Addendum #2

Project Name: Shadow Mountain Drive Reconstruction

Project Number: 41ESMDR

SHADOW MOUNTAIN DRIVE
 RECONSTRUCTION
 DETAILS

1 TYPICAL PAVEMENT SECTION
 NOT TO SCALE
 STA: 1+00 TO 34+45

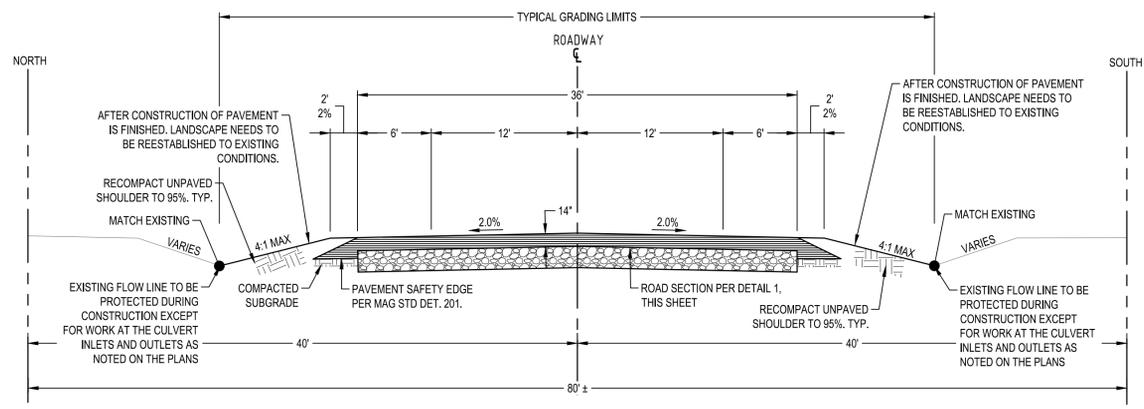
Typical Pavement Section Detail #1 on Sheet C2.1 has been revised to include: “EXISTING GEOGRID BETWEEN NATURAL SUBGRADE AND AB SHALL BE REMOVED DURING THE ROADWAY EXCAVATION.” Bid schedule shall remain as is; this work shall be incidental to Bid Item #7 (Keynote 100).

ITEM:	ADDED GEGRID TO PAVE SECTION 1
DATE:	02/07/2025
NO.:	1
REVISIONS:

4 EXISTING GEOGRID BETWEEN NATURAL SUBGRADE AND AB SHALL BE REMOVED DURING THE ROADWAY EXCAVATION.
